# Access Compliance Report

## Public Rights-of-Way

Intersection ID: 10011804	Main Street: MASONIC_DR	Cross Street: N/A	Location: E
ADA ID: B90146E6D23E	Ramp Type: BlendTrans2	Initial Pass/Fail: Pass	Overall Compliance: No
		Severity Score: 7.75

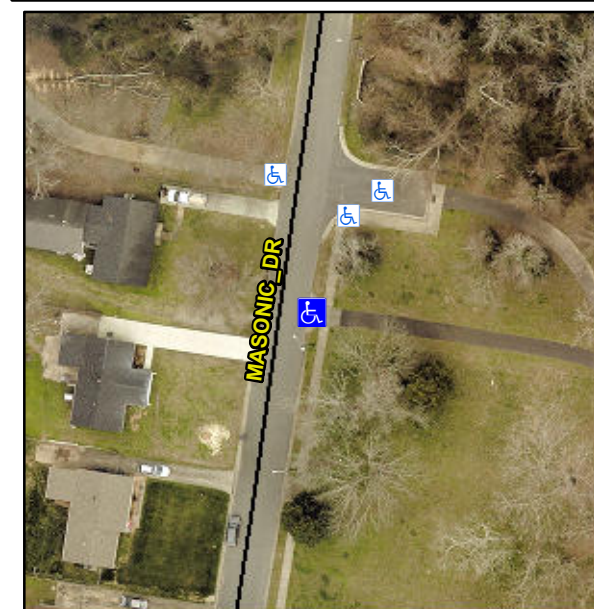
**Not Found, R304.5.3, R305.1.4, R304.5.4**

Compliance	Description	Data	Compliance	Description	Data
N/A	Ramp Length (in)	115.0	Yes	BlendTrans Slope (%)	2.4
Yes	Ramp Width (in)	123.0	No	BlendTrans XSlope (%)	2.6
N/A	Flare Type LT	Sloped	N/A	Flare Type RT	Sloped
N/A	Flare Slope LT (%)	N/A	N/A	Flare Slope RT (%)	N/A
N/A	Flare Traversable LT?	No	N/A	Flare Traversable RT?	No
N/A	Landing Length (in)	N/A	Yes	DWS Provided?	Yes
N/A	Landing Width (in)	N/A	Yes	DWS Contrast?	Yes
N/A	Landing Slope (%)	N/A	Yes	DWS Length (in)	24.0
N/A	Landing X Slope (%)	N/A	No	DWS Full Width?	No
N/A	Landing Curb? (Y/N)	No	Yes	DWS Offset (in)	0.0
N/A	Shared Landing?	No			
Yes	Gutter Ponding?	No	No	Gutter Slope (%)	5.5
Yes	Gutter Lip Ht (in)	0.0	Yes	Gutter X Slope (%)	2.0
N/A	Painted X Walk1?	No	N/A	Painted X Walk2?	N/A
	X Walk 1 Direction	To W		X Walk 2 Direction	N/A
	X Walk 1 Width (in)	N/A		X Walk 2 Width (in)	N/A
	X Walk 1 Slope (%)	2.2		X Walk 2 Slope (%)	N/A
	X Walk 1 X Slope (%)	1.3		X Walk 2 X Slope (%)	N/A

N/A	Ramp inside XWalk1?	N/A	N/A	Ramp inside XWalk2?	N/A
	Road Slope (%)	1.3		Clear Space?	Yes
	Road X Slope (%)	2.2	N/A	Clear Space to XWalk (in)	N/A
Yes	Any Obstructions?	No	Yes	Storm Grate/Utility Hazard?	No
	Obstruction Type			Storm Grate/Utility Type	
		N/A			N/A
			Yes	Surface Condition? (G/P)	Good
			No	Curb Slope (%)	7.6

**Remove & Replace Curb Ramp With Two New Directional Ramps or Equivalent. Remove & Replace Gutter.**
